## **Minutes of Pre Bid Meeting**

**Name of work: "Comprehensive Design Consultancy for GGSIPU at Sector 16 C, Dwarka, New Delhi.SH: Dwarka Campus Phase – II"**

**NIT: 18/SE/UWD/2013-2014**

Master Plan (Shaded Portion Indicates Buildings Constructed in Phase I)

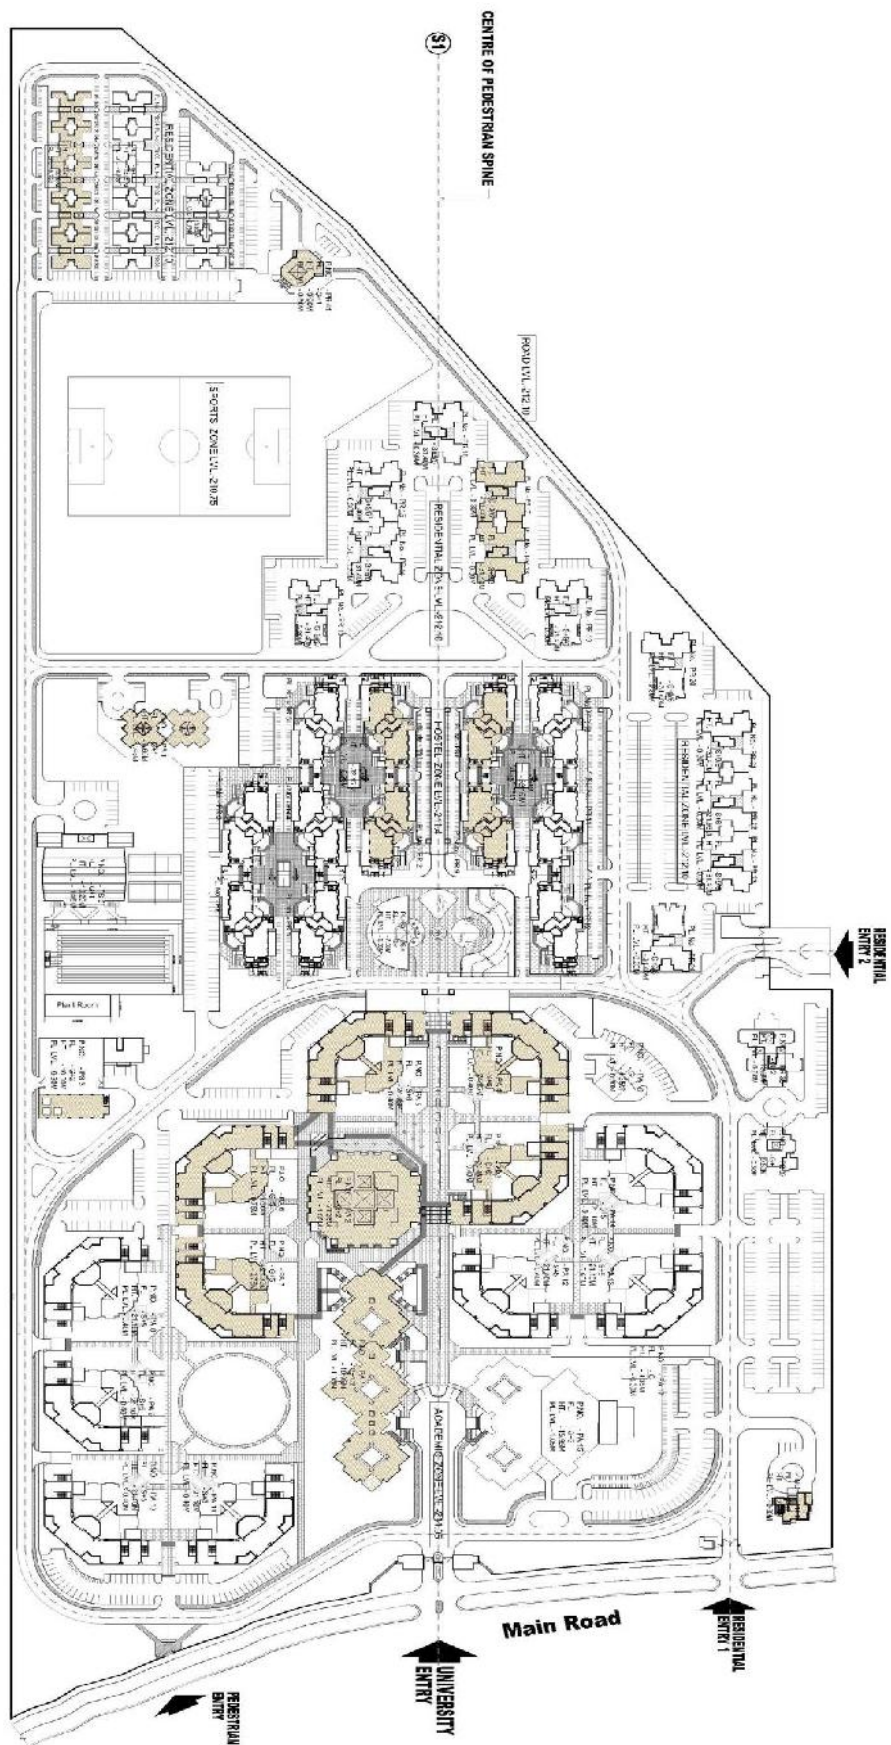
21.	<p>Site Map (Page-78): Kindly mark the site for phase-2 development &amp; provide the autocad drawing of site for preparation of design.</p>	For Master plan in Auto cad format refer point no. 1 above. Drawing showing buildings constructed in Phase I shall also be uploaded alongwith minutes of pre-bid meeting.

77.	Site plan does not indicate whether these are existing structure and no legend indicating A. B. etc., is provided.	Refer reply to point no 21 above.
